MPD (EAF) at TP2 specification refinement

Rubén Pérez-Aranda
(rubenpda@kdpof.com)

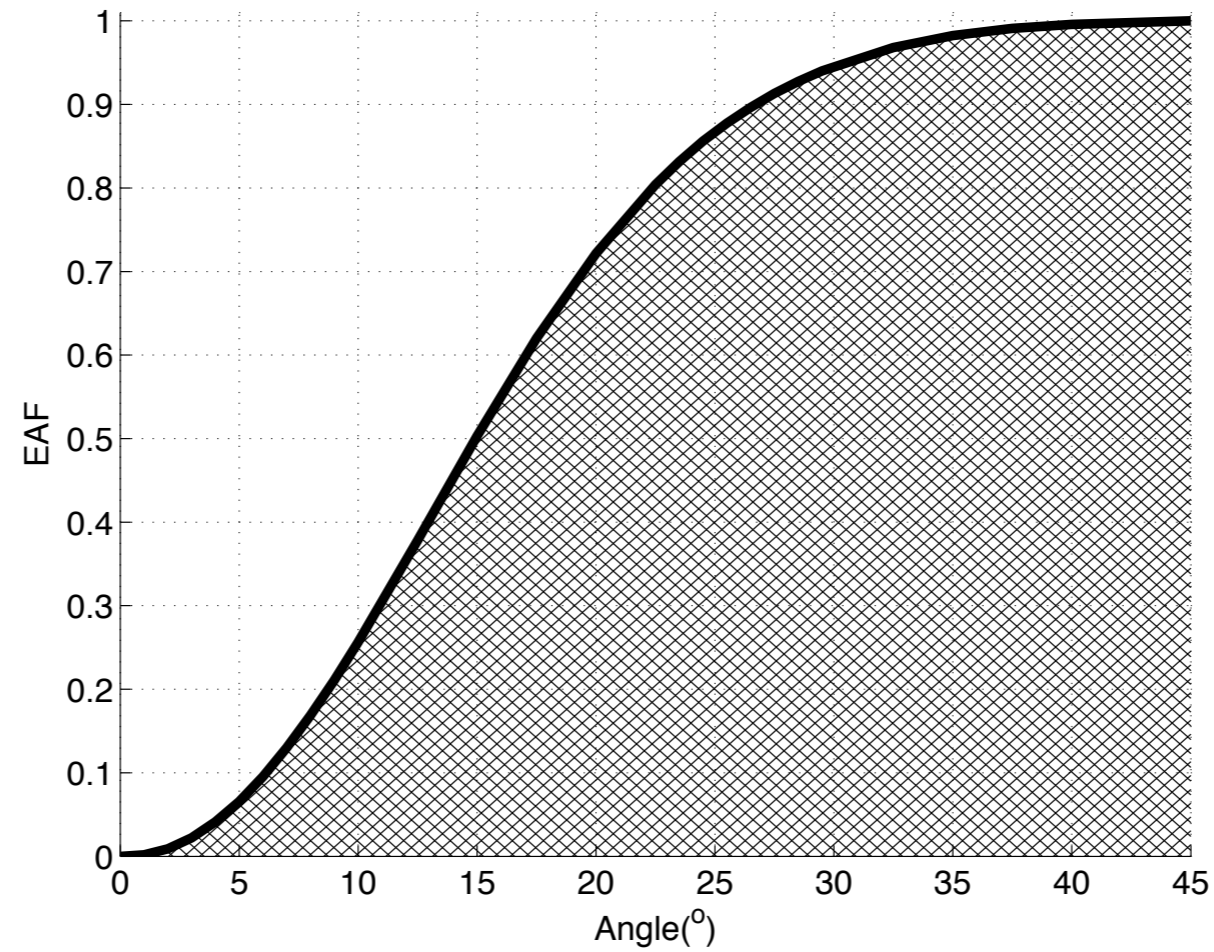
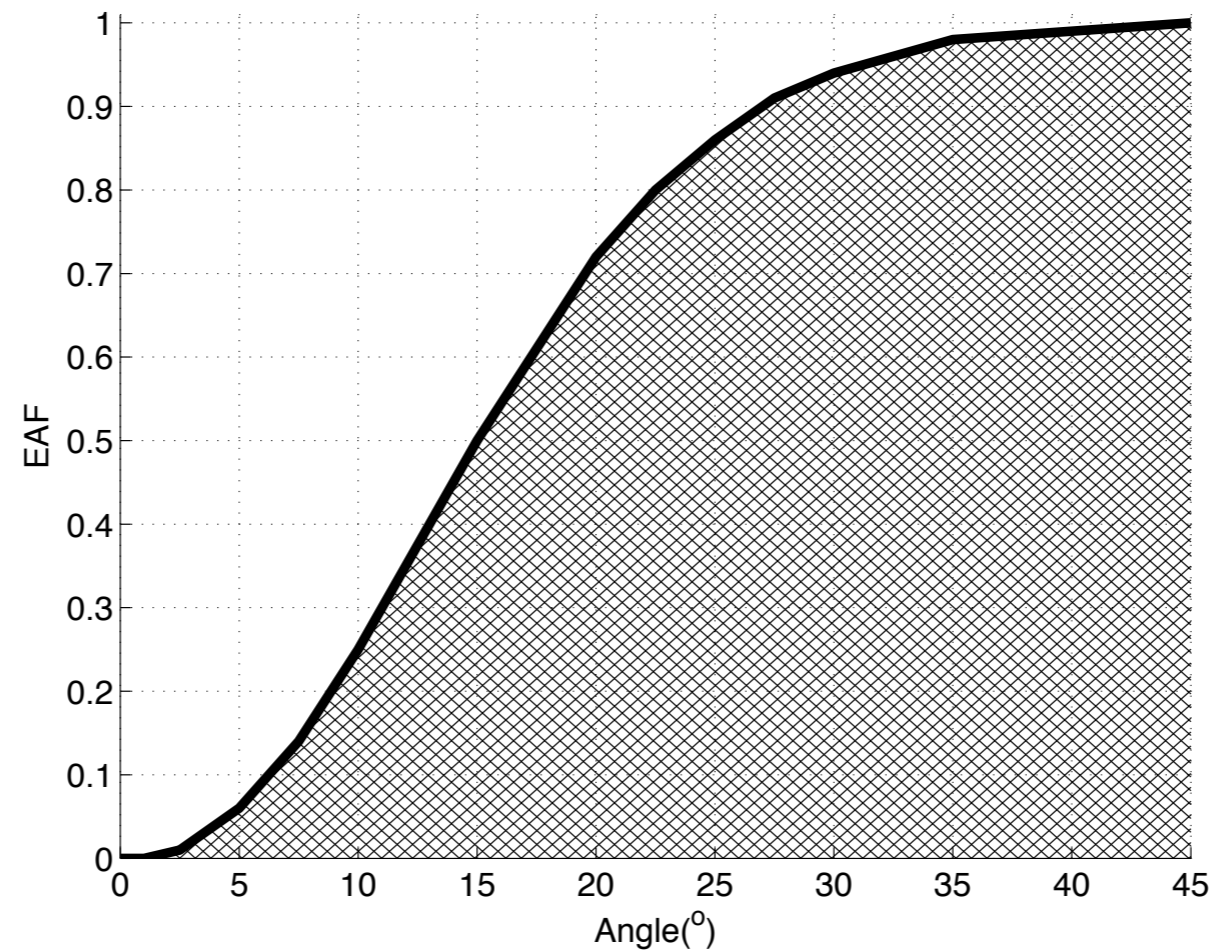
MPD per EAF at TP2 - 802.3bv D1.3

MPD per EAF at TP2 - refinement for D1.4

Angle (o)	EAF	Angle (o)	EAF	Angle (o)	EAF
0.0	0.00	10.0	0.25	27.5	0.91
1.0	0.00	15.0	0.50	30.0	0.94
2.5	0.01	20.0	0.72	35.0	0.98
5.0	0.06	22.5	0.80	40.0	0.99
7.5	0.14	25.0	0.86	45.0	1.00
